MEMORANDUM

SUBJECT: CONCEPT REVIEW OF 802-808 NORTH WASHINGTON STREET
BAR CASE # 2024-00460

The applicant is requesting BAR Concept Review for the development of the property at 802-808 North Washington Street into a multi-unit residential building.

Figure 3: Plan showing proposed roof deck at historic townhome

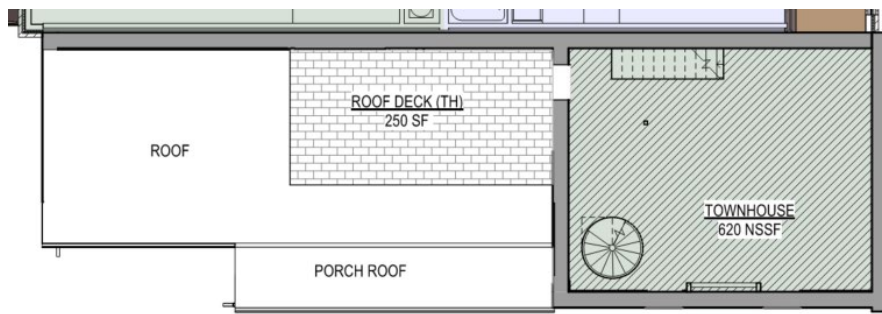
Under both the previously approved design, there was little modification to the historic townhome proposed with the exception of the connection to the north elevation. Under the current proposal the applicant is proposing the introduction of a roof deck to the rear ell at the historic townhome. This roof deck is shown on the submitted plans (Figure 3) but not on the renderings so it is unclear how it will be constructed. Staff recommends that the applicant return with details showing how the roof deck will be integrated into the historic building for feedback from the BAR.
